NOTICE OF DECISION

Virginia Garcia Memorial Health Center – Newberg Clinic – 2251 E Hancock Street
Variance Request and Design Review – VAR22-0003 / DR222-0010

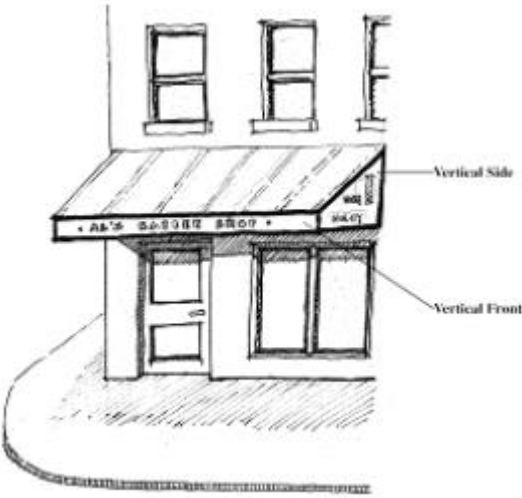
Response: See A7.6 for conformance with section

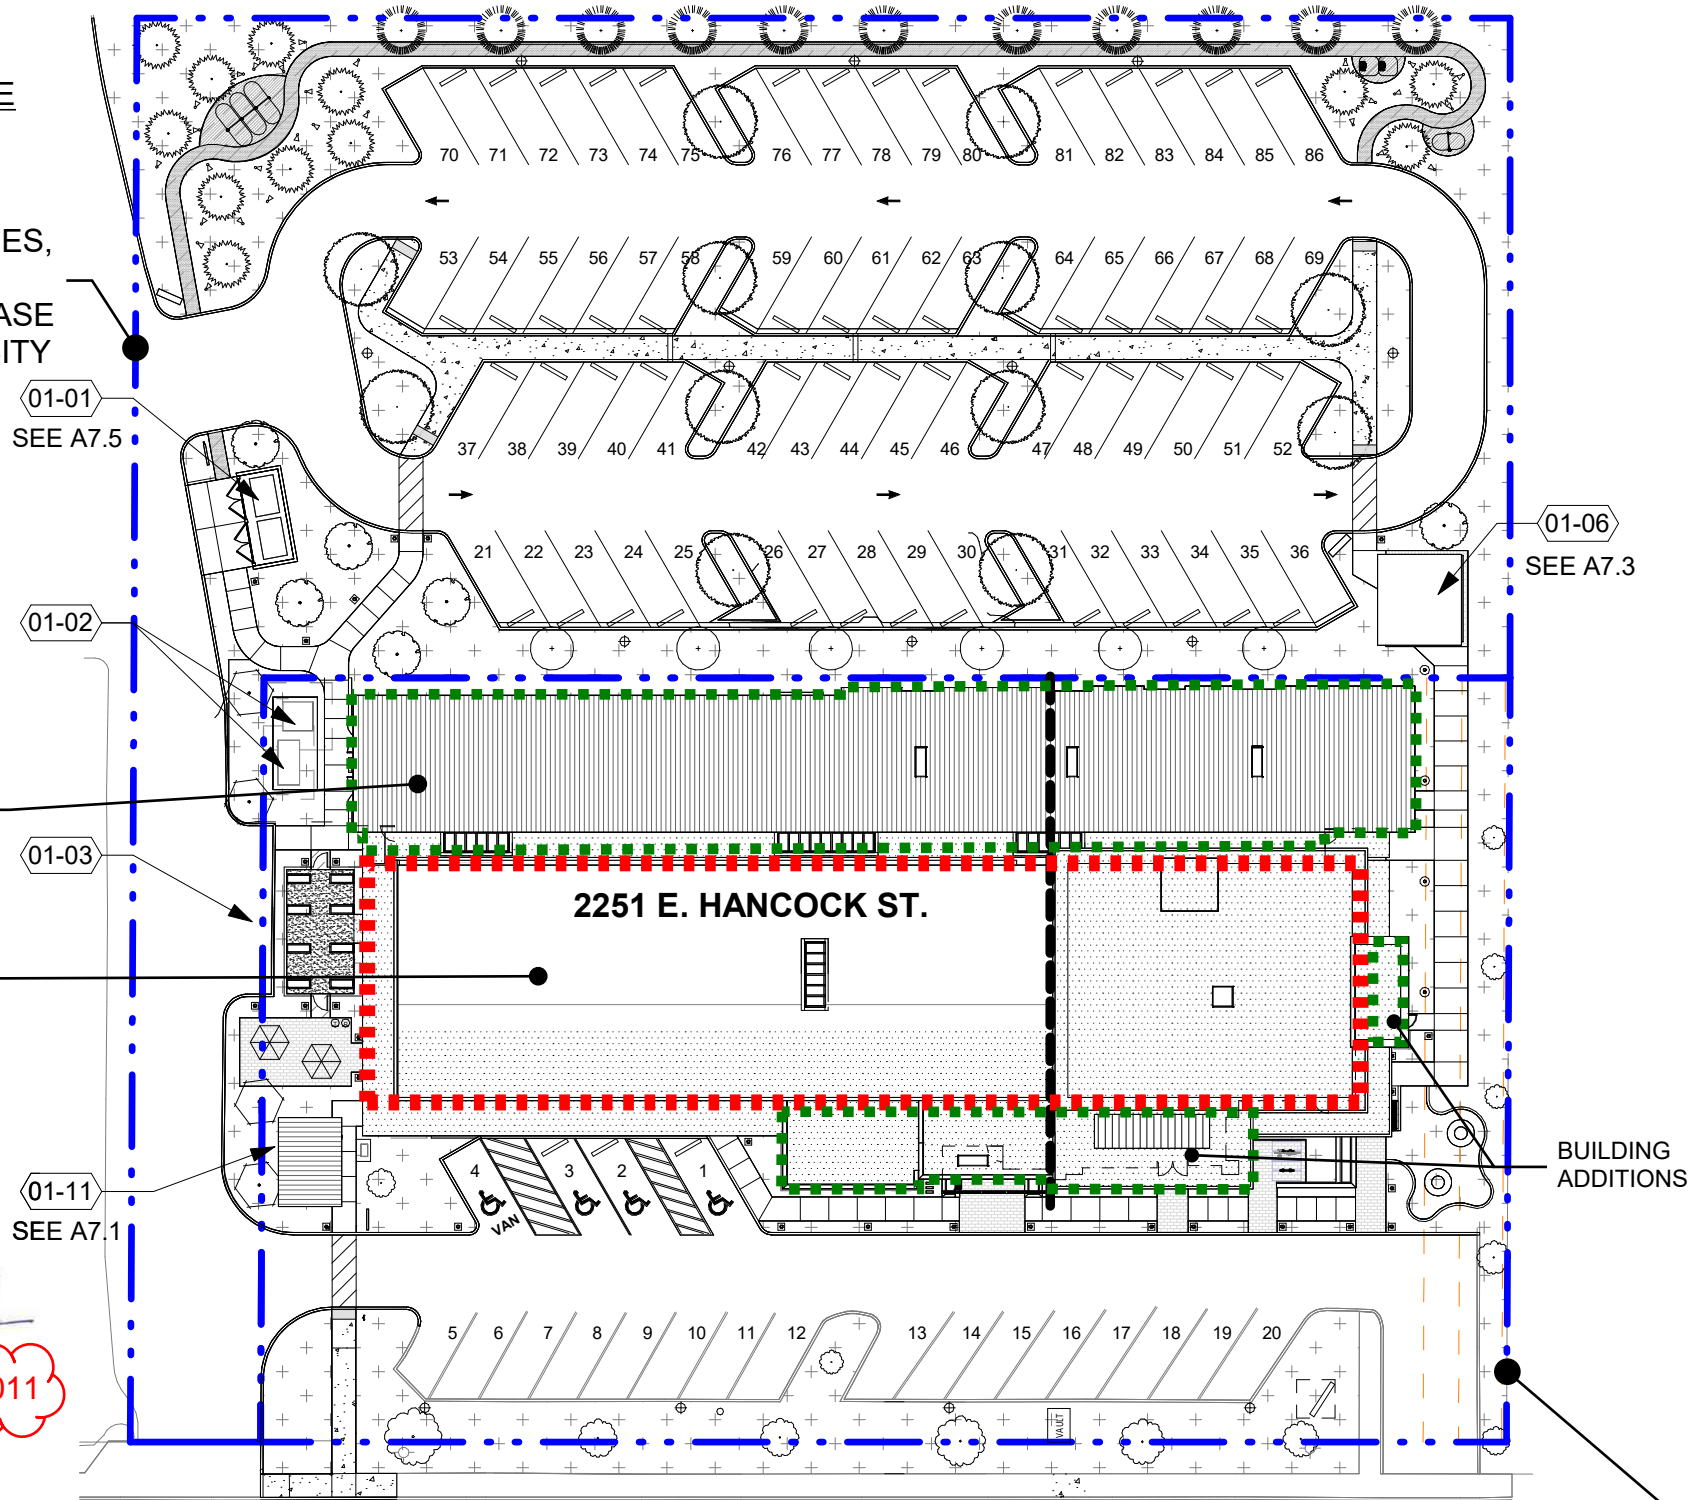
Inspection Comments:
